PARTS & SERVICE NEWS

REF NO.	AT02089A
DATE	Sep. 11, 2003
(C) Page 1 of 11

SUBJECT: REPAIR PROCEDURE OF A/C COMPRESSOR ADJUSTMENT ROD & PULLEY COVER ON HD325, 405-6

PURPOSE: \triangle To introduce modification procedure to repair breakage of the drive belt adjusting rod and cracks in the air compressor pulley cover and in the bracket mounting bolts on HD325-6 and HD405-6 dump trucks

Fig. 2

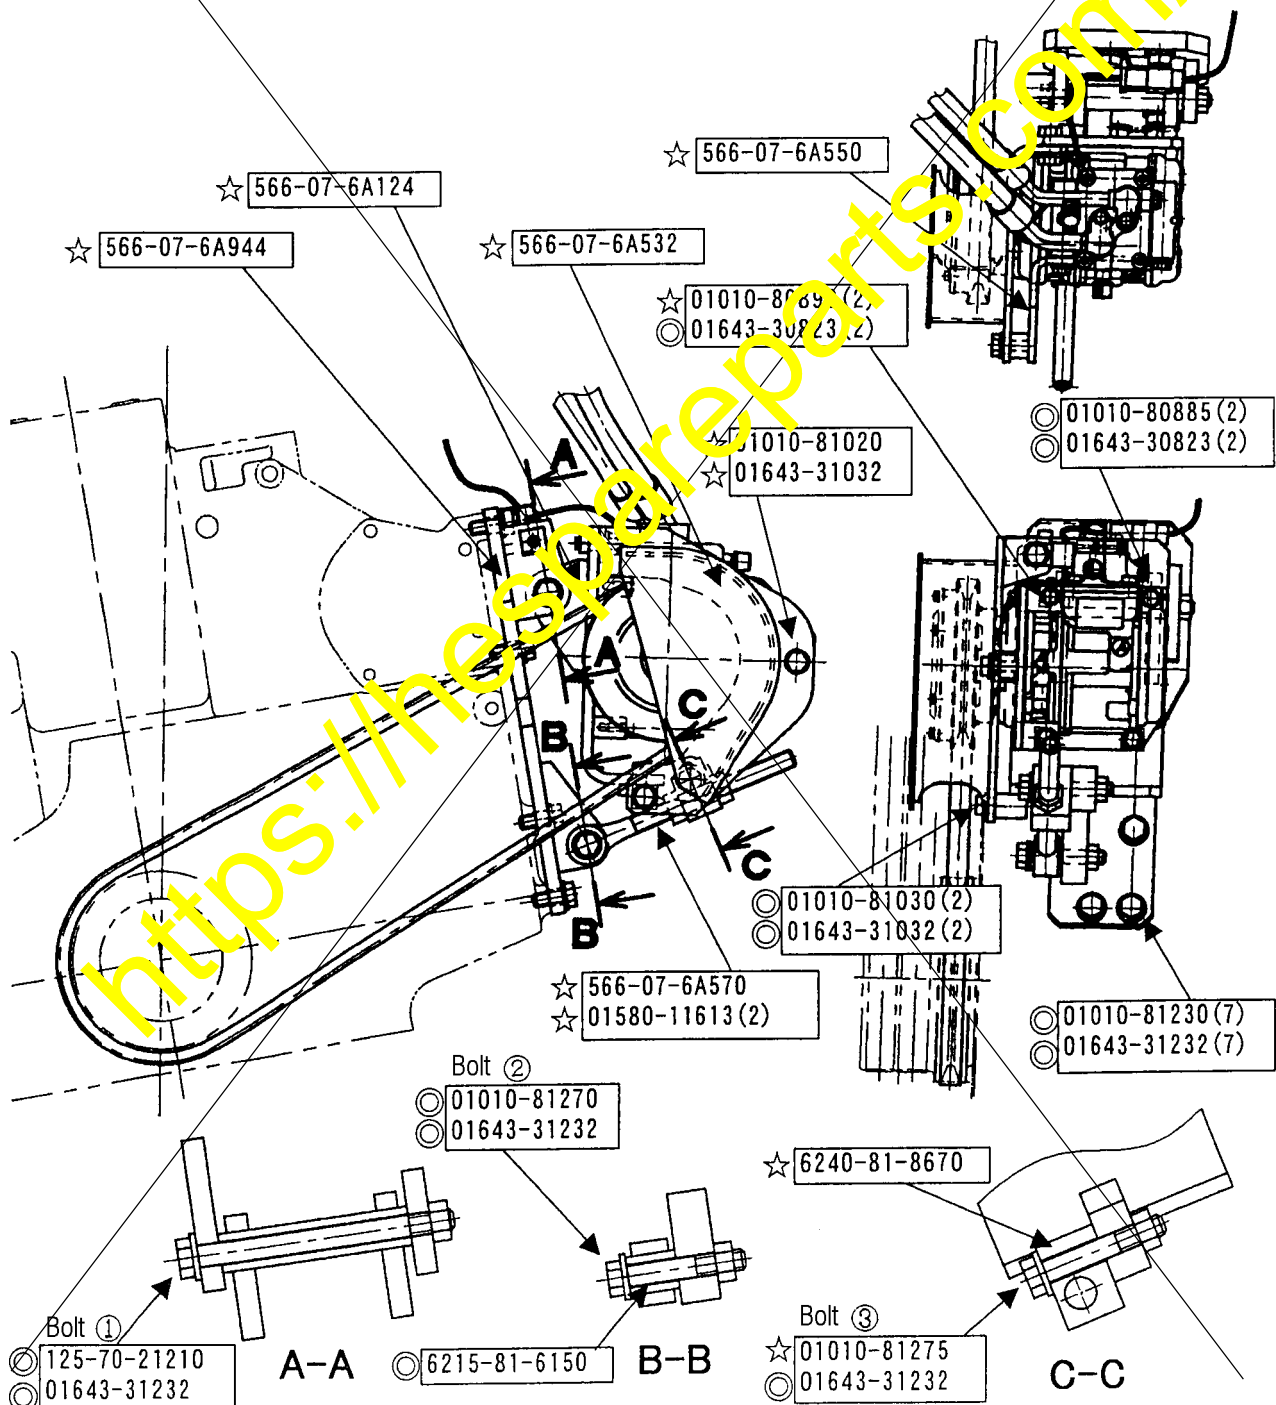
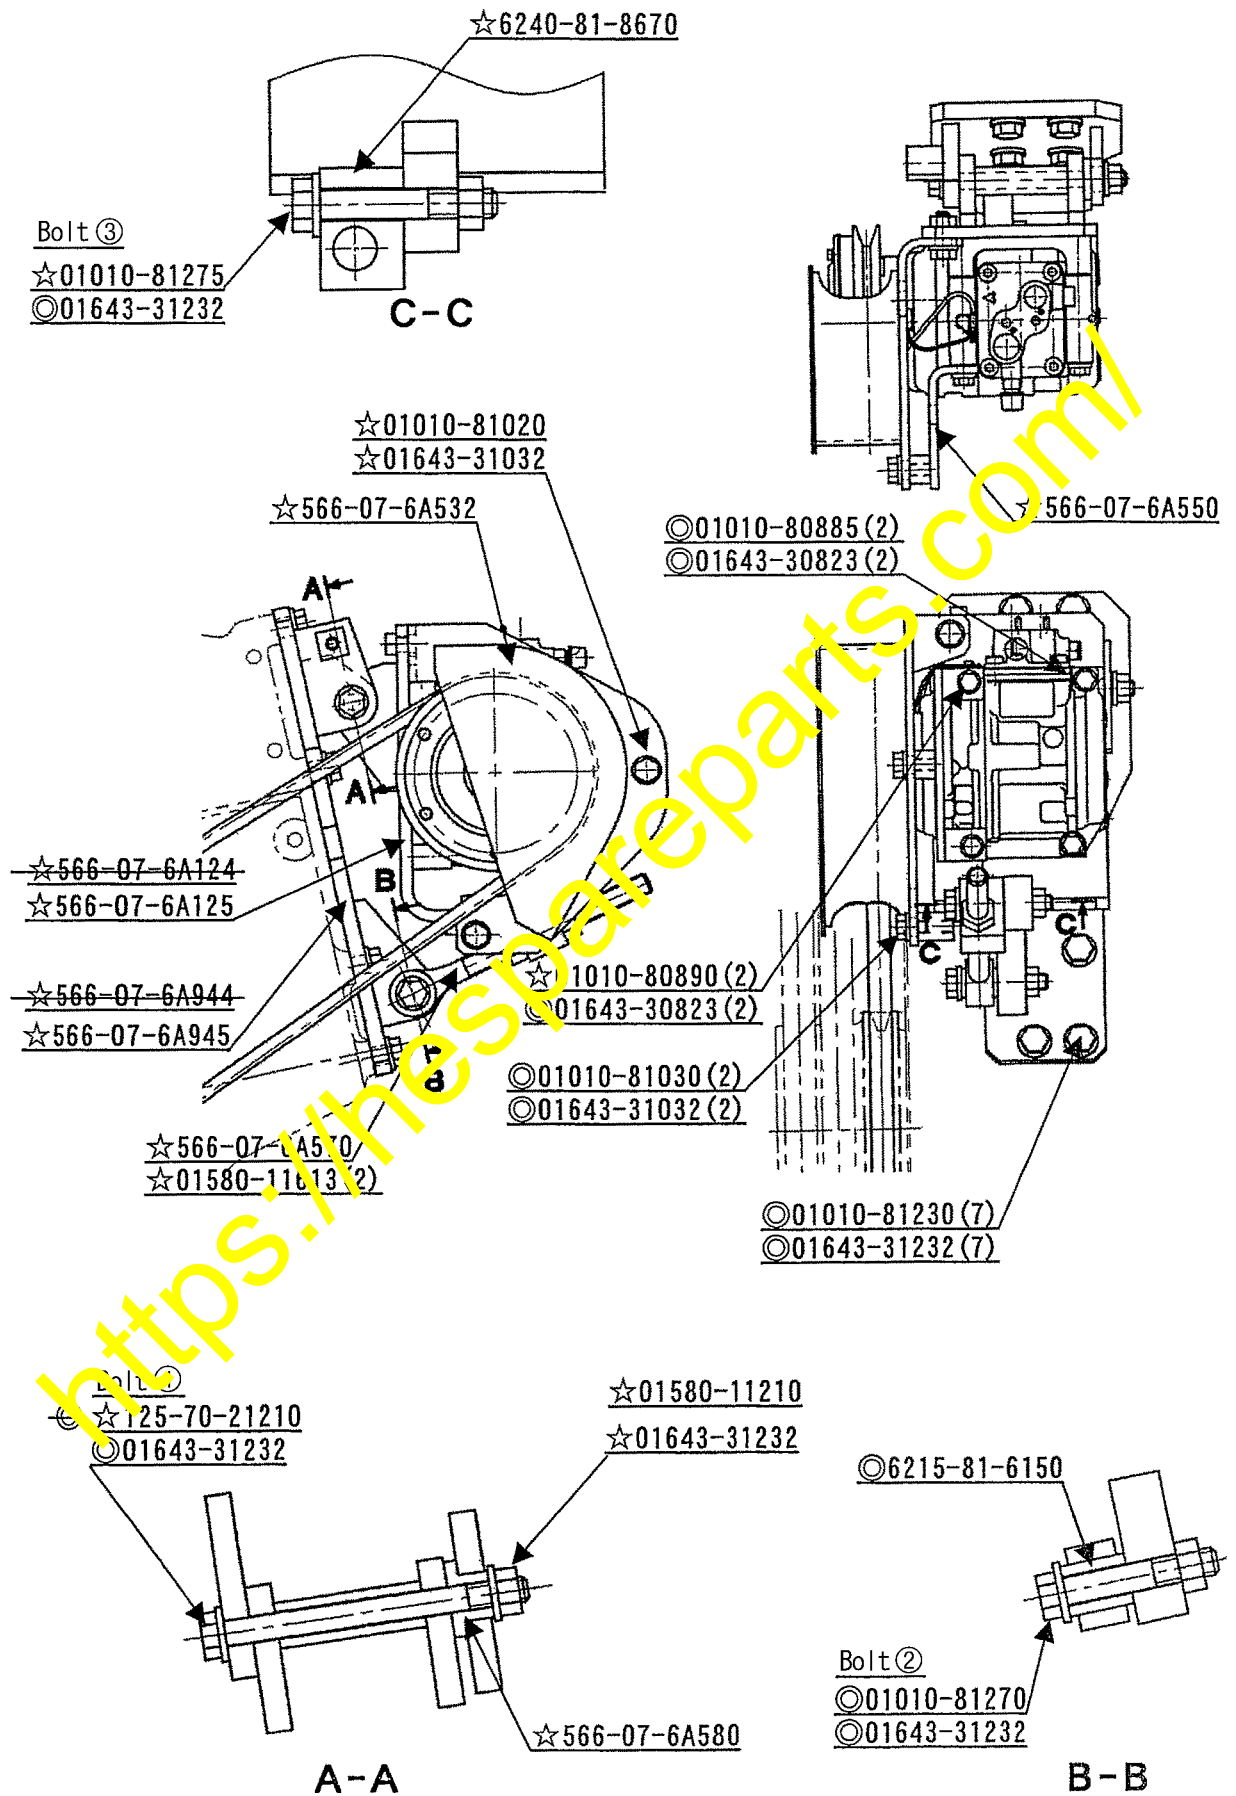
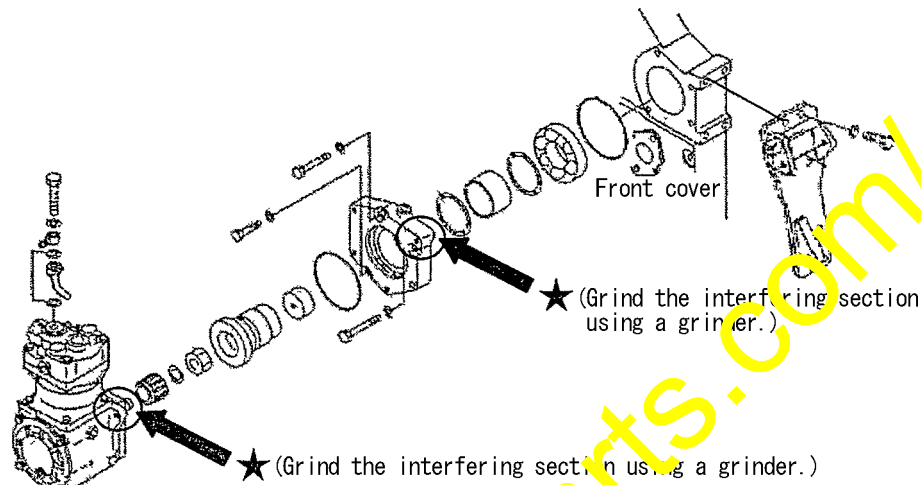
-  1) Install the bracket (566-07-6A944) to the engine.
 2) Install the bracket (566-07-6A124). Lightly screw-in the bolt 1 and leave it in loosened state.
 3) Install the air compressor to the bracket (566-07-6A124). At this time, install the bracket (566-07-6A550) using the mounting bolts commonly.
 4) Install the rod (566-07-6A570) and plate (6240-81-8670). At this time, lightly screw-in the bolts 2 and 3 leave them in loosened state.

- 1) Install the improved engine side bracket (566-07-6A945) to the engine using the bolt (01010-81230) and washer (01643-31232).

At this time, if the sections marked ★ shown in the figure below interfere with the rear surface of the bracket, grind the housing of the compressor using a grinder, etc. to prevent occurrence of the above interference.

- 2) Install the improved compressor side bracket (566-07-6A125) to the engine side bracket using the bolt ① (125-70-21210), washer (01643-31232) and collar (566-07-6A580). Keep the bolt ① loosened.
- 3) Install the compressor to the bracket (566-07-6A125) using the bolts (01010-80890 and 01010-80885) and washers (01643-31232). At this time, install the bracket (566-07-6A550) together by use of the same mounting bolts.
- 4) Install the tension rod (566-07-6A570) to the engine side bracket using the bolt ② (01010-81270), washer (01643-31232) and pin (6215-81-6150). Keep the bolt ② loosened.
Connect the tension rod and the compressor side bracket using the plate (6240-81-8670), bolt ③ (01010-81275) and washer (01643-31232).
Keep the bolt ③ loosened.

Fig. 3

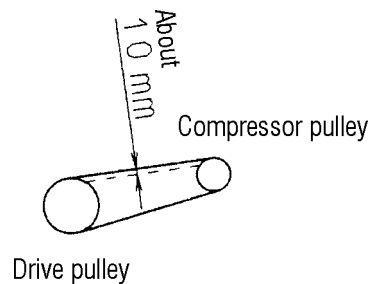
- 5) Setting the drive belt on the air compressor pulley, adjust the nut (01580-01613) to tighten the belt tension. (Refer to Fig. 3)
(Tighten the belt tension so that the belt will be deflected by about 10 mm when the center point of the belt is depressed by the thumb (at 58.8 N {6 kgf}.)
-  Install the nut (01580-11613) securely to the both sides of the plate (6240-81-8670).
